# **UCP-3901**

# **IQUCP25 / IQUCP50**

VERSION 17.0

## **Release Notes**

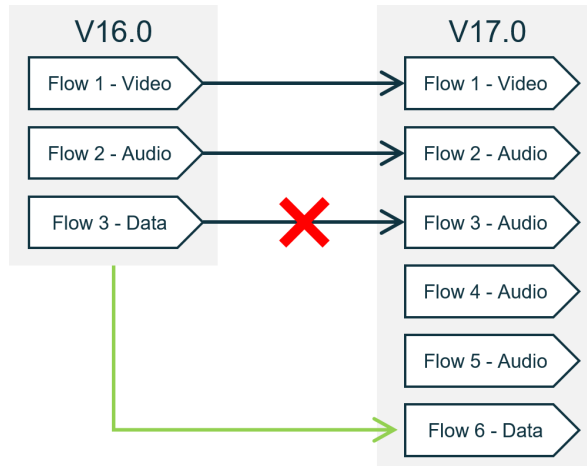
As shown below, when migrating from version 16.0 to 17.00, due to the addition of 3 new audio channels, the metadata flow has been moved from flow 3 to flow 6, so any existing metadata routing will be need to be reviewed.

With the introduction of V17.0 and multiple audio flows, it is recommended that the system is cleared down of all spigot addresses, flows remapped, and where necessary GV Orbit reconfigured to account for the additional flows. Not doing this potentially introduces the risk of unpredictable behavior.
